IA-32 Intel[®] Architecture and Intel[®] Extended Memory 64 Technology Software Developer's Manual

Documentation Changes

November 2004

Document Number: 252046-011

Figure 4-6. Examples of Accessing Conforming and Nonconforming Code Segments From Various Privilege Levels

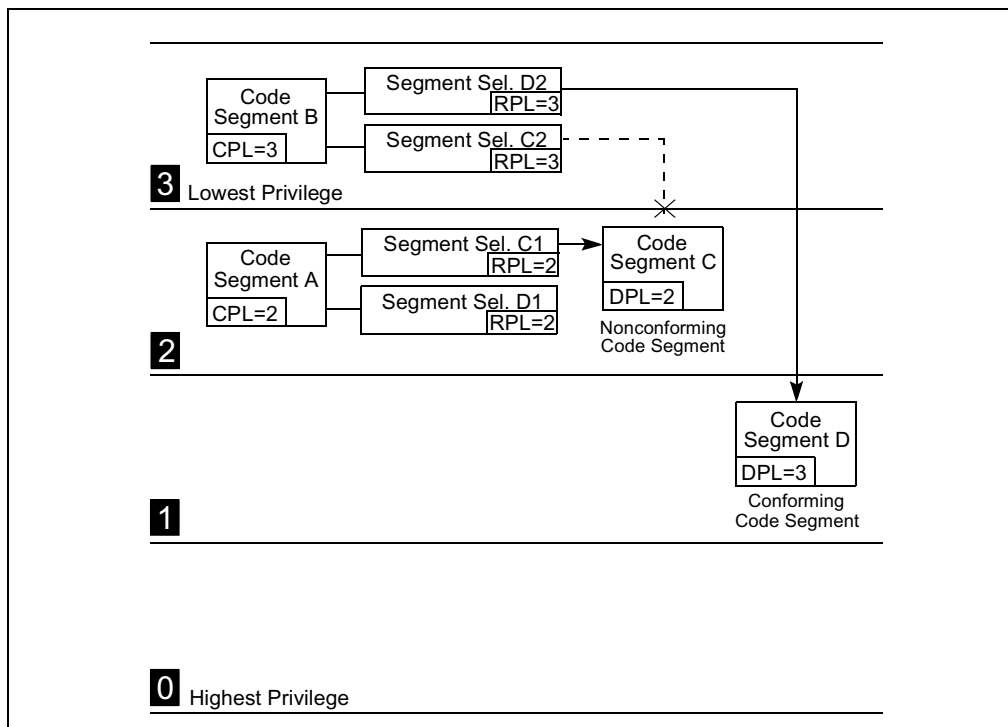
IA-32 Intel Architecture Software Developer's Manual, Volume 3; Figure 4-6: a line that incorrectly indicated privilege access was removed. The corrected figure is reprinted below.

Figure 3-1. Bit Offset for BIT[RAX, 21]

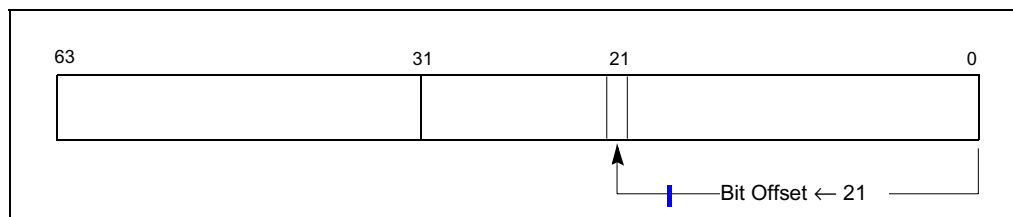
IA-32 Intel Architecture Software Developer's Manual, Volume 2A; Section 3.1.1.7: text in the Bit(BitBase, BitOffset) subsection will be updated to accommodate 64 bits. Data in this section impacts the following instructions: BT, BTC, BTR and BCS. All affected areas are marked with change bars.

- Bit(BitBase, BitOffset)** — Returns the value of a bit within a bit string. The bit string is a sequence of bits in memory or a register. Bits are numbered from low-order to high-order within registers and within memory bytes. If the BitBase is a register, the BitOffset can be in the range 0 to [15, 31, 63] depending on the mode and register size. See Figure 3-1: the function Bit[RAX, 21] is illustrated.

Figure 3-2. Memory Bit Indexing

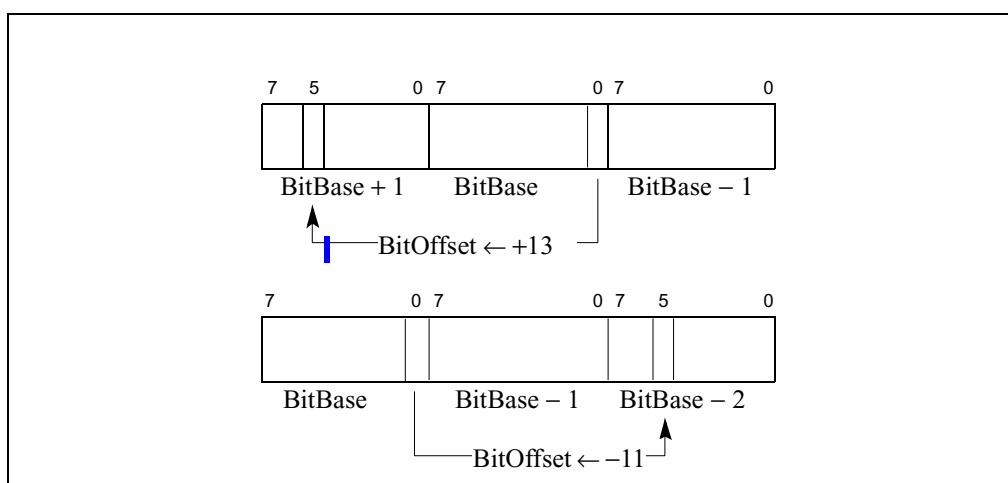
The addressed bit is numbered (Offset MOD 8) within the byte at address (BitBase + (BitOffset DIV 8)) where DIV is signed division with rounding towards negative infinity and MOD returns a positive number (see Figure 3-2).

Figure 3-5. Version Information Returned by CPUID in EAX

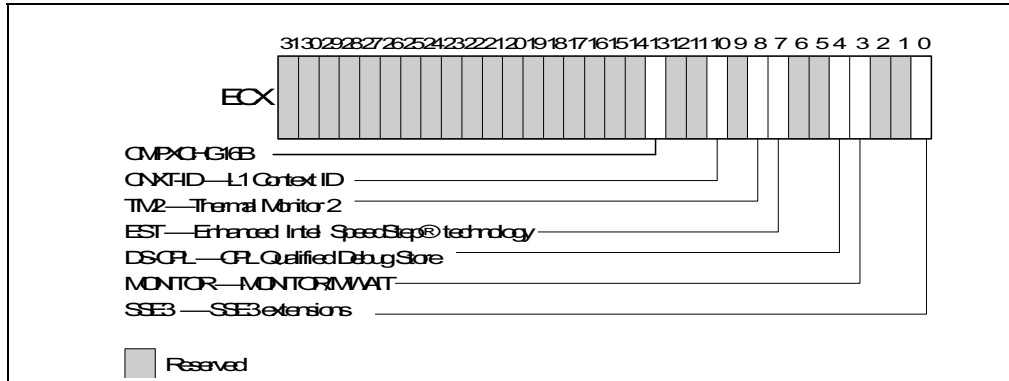
IA-32 Intel Architecture Software Developer's Manual, Volume 2A; Chapter 3, CPUID section: the subsection on family and model information has been updated. The updated text has been marked by change bars (in context).

When CPUID executes with EAX set to 1, version information is returned in EAX (see Figure 3-5). For example: model, family, and processor type for the first processor in the Intel Pentium 4 family is returned as follows:

Figure 14-5. IA32_MCi_CTL Register

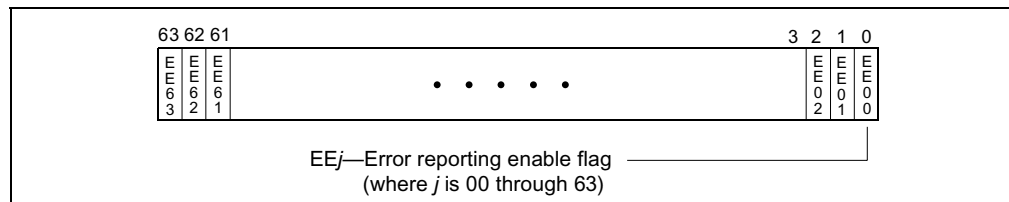
IA-32 Intel Architecture Software Developer's Manual, Volume 3; Section 14.3.2.1: text has been updated to clarify MC Reporting/Logging. The updated text is marked by a change bar.

Figure 7-5. Interpretation of the APIC ID

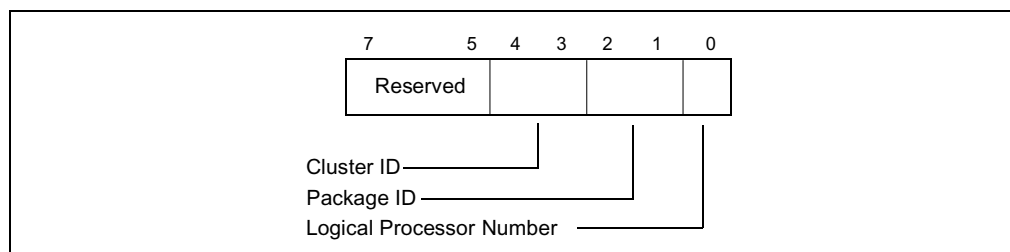
IA-32 Intel Architecture Software Developer's Manual, Volume 3; Section 7.7.5: text has been updated to correct inconsistencies in naming processor IDs and calculation of the ID bits. The affected areas have been marked by change bars.

In future IA-32 processors supporting Hyper-Threading Technology that implement more than two logical processors per physical processor, the logical processor bit shown in Figure 7-5 will be expanded to a 2- or 3-bit field to allow each of the logical processors to be identified. The package ID and cluster ID fields will be shifted left. Also, the package ID may be expanded to more than 2 bits, requiring the cluster ID field to be shifted left.

Figure 7-5 depicts the layout of cluster ID, package ID and logical processor number bit fields of an APIC ID for current implementations of HT Technology (two logical processors per package). The number of bits that are reserved for the logical processor number can be computed by:

Figure 3-6. Extended Feature Information Returned in the ECX Register

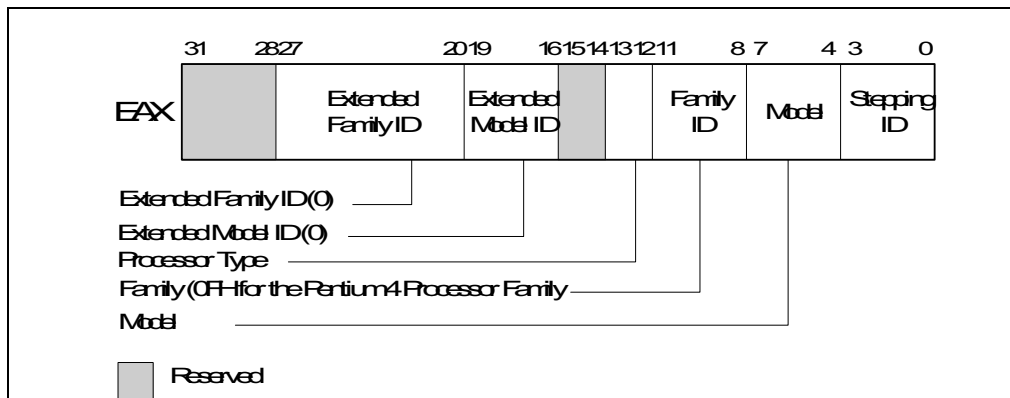
IA-32 Intel Architecture Software Developer’s Manual, Volume 2A; Chapter 3, CPUID section: information about the CMPXCHG16B feature flag has been added to the extended feature information returned when EAX =1. Added text has been marked by change bars.
